United Walnut Taxpayers (UWT)  
P.O. Box 1665  
Walnut, CA. 91788  
Contact Person, Layla Abou-Taleb, President

**UWT Response to the July 2017 NOC of Tiered Draft EIR for the Mt. SAC West Parcel Solar Project**

United Walnut Taxpayers is providing comments on the West Parcel Solar Project Tiered Project Draft EIR to 2012 Facilities Master Plan Program EIR. Comments are divided into aesthetic effects, alternatives evaluation, costs evaluation, and review of 2014 and 2017 Converse study reports and 2017 DEIR Geology and Soils section. A Table of Contents is provided below.

**Central Hill Landslide Area (close up and broader view)**

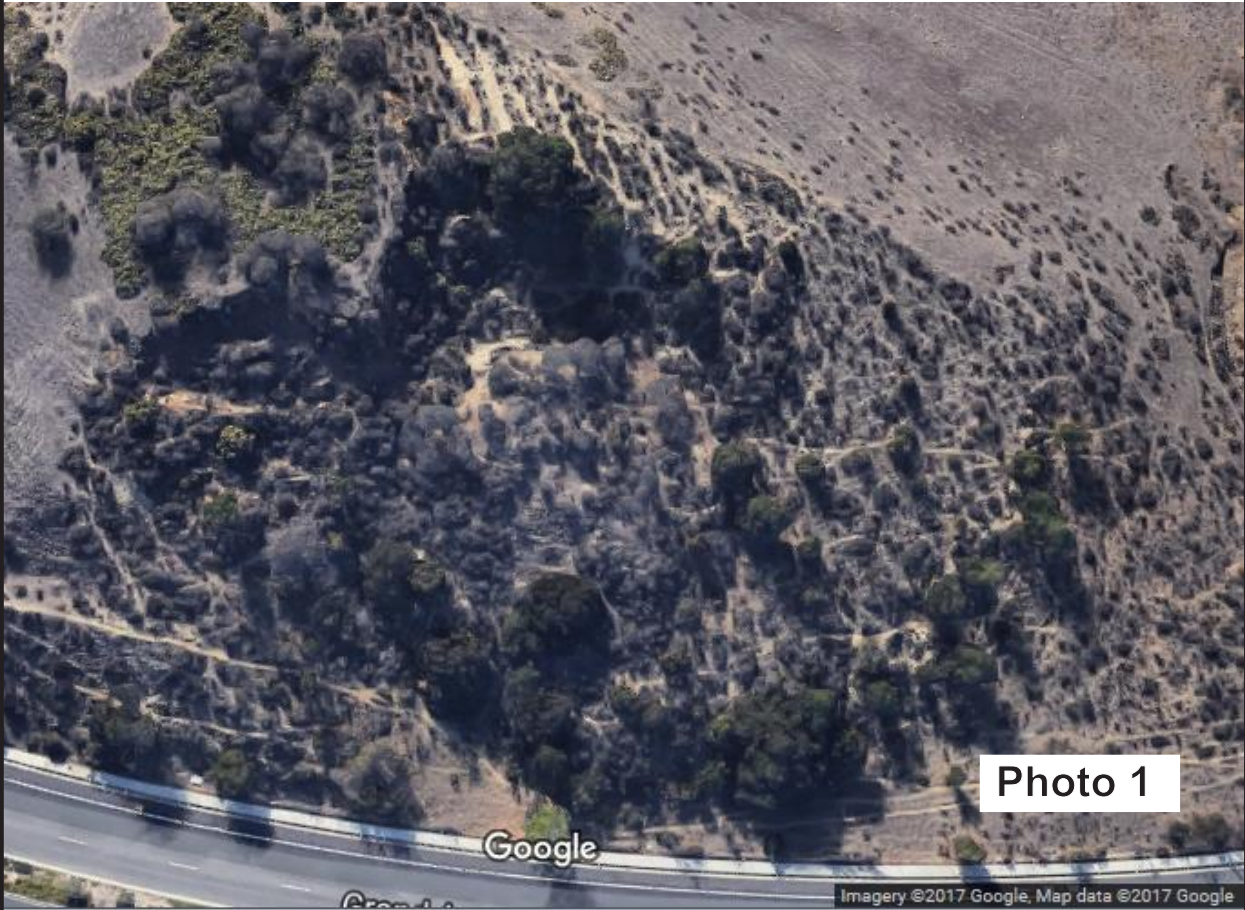
TSI conducted a brief review of the potential for landsliding at the site. A review of aerial imagery from Google Earth clearly indicates a landslide(s) exists on the eastern side of the central hillside area descending to Grand Avenue (Photo's 1 and 2). This landslide area is present in aerial imagery dating from after 1980 until the present. The presence of this landslide complex was further confirmed based on the brief field reconnaissance on March 30, 2017. In addition, siltstone and shale bedrock with eastward dipping (toward Grand Avenue) bedding was also observed in this area.

A second site walk was conducted on April 12 with the former mayor of the City of Walnut (June Wentworth). She said that at least two landslides occurred at the subject site after Grand Avenue was expanded to its current four lane configuration in the late-1970's. According to the former Mayor, at least one of the landslides closed the road (Grand Ave.) and covered all the lanes. She indicated that the landslide material was removed from the road and a small wall was constructed to reduce further debris from covering the road at one of the areas. Ms. Wentworth remembers being told by the City's Engineer that *“This hillside area was unstable and should never be developed”*. Figure 4 is a compilation of a photograph showing Grand Avenue in 1967 and the current ground surface based on 2011 Psomas topography. This figure clearly shows the pre-grading conditions and that the central hillside area has significantly changed its profile due to the grading and the landslide that occurred. Figure 5 is an aerial view of the area of the landslide in 1980 with the projection of the limits of the initial cut slope based on as built drawings (1979). This figure also shows the limits of the area that failed after the slope was constructed, including the landslide escarpment at the top of the central hill. Photo's 3 and 4 show the current scarp to the landslide in the central hill area.

**Figure 1**

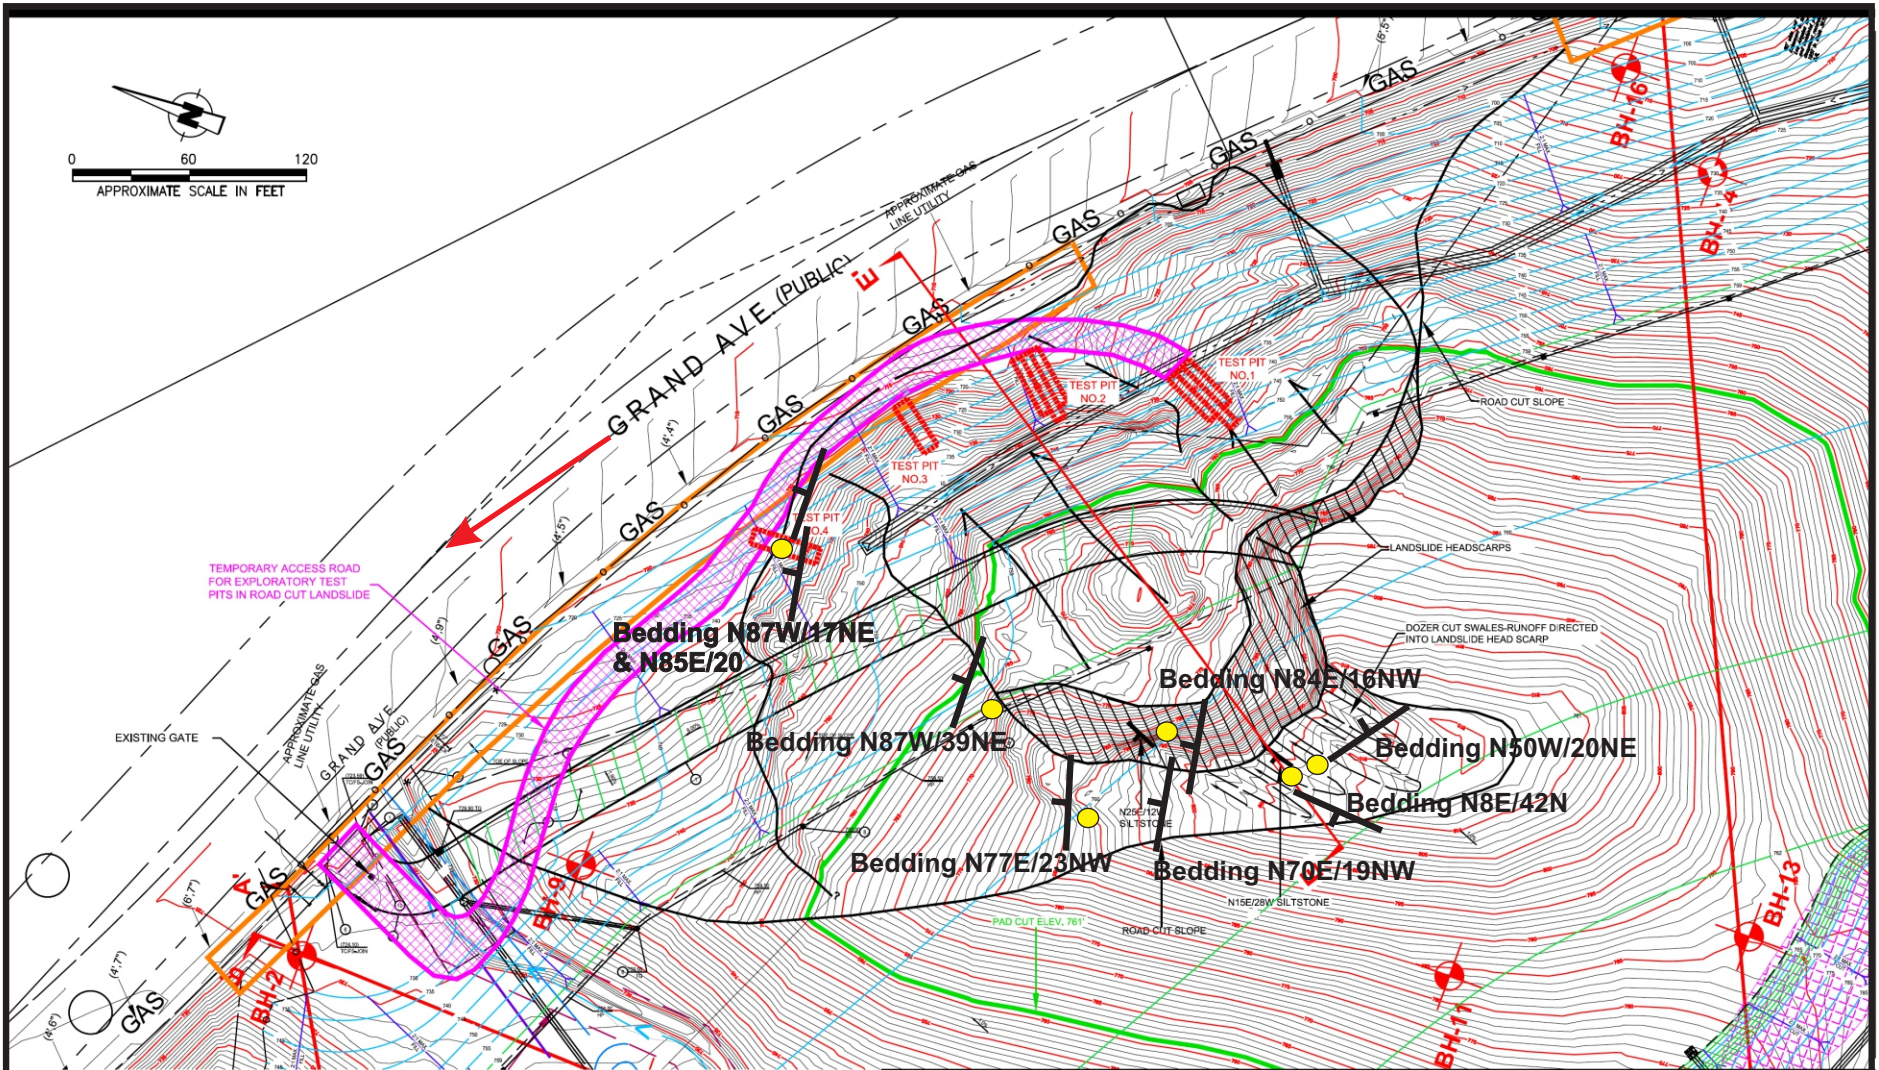
The Converse report identifies a landslide in all four of the test pits excavated, and Drawing No. 1 has several lines possibly indicating the limits of the landslide or several landslides. The limits of the landsliding is unclear because not all lines are labeled and no legend is provided for Drawing No. 1. Four arrows are shown that likely indicate the direction of landsliding (one or two landslides) however, in the area of Test Pit No. 4 there are no arrows and the line which may show the limits of landsliding is discontinuous to the west and ends with a question mark. An area that is indicated as landslide headscarp is indicated on Drawing No. 1. There is no discussion in the text of the report regarding multiple landslides, multiple pieces of the same landslide, or the limits of landsliding.

- Test Pit No. 4 (Drawing 1d) indicates the presence of landslide debris in the upper portion of the test pit and along the back wall of the excavation. TSI’s observation of this excavation did not indicate the presence of any significant landslide debris along the west wall or the back wall of this excavation. Photo 1 (A and B) clearly shows fractures within similar looking bedrock, that extend from near the surface to the total depth of the test pit. The test pit log describes the material above the slip plane (approximately 7 feet above the bottom of the pit)

as “disturbed, loose, broken” yet as indicated in the photos the material above and below this depth is very similar in consistency, and was not observed to be significantly disturbed, loose and broken. Bedding was observed to be consistent in the rear and side wall from near the surface to the bottom. TSI’s interpretation of this Test Pit is that it is primarily bedrock which is significantly different than as presented by Converse on Drawing No. 1d. The bedrock at this location has out-of-slope dipping bedding.
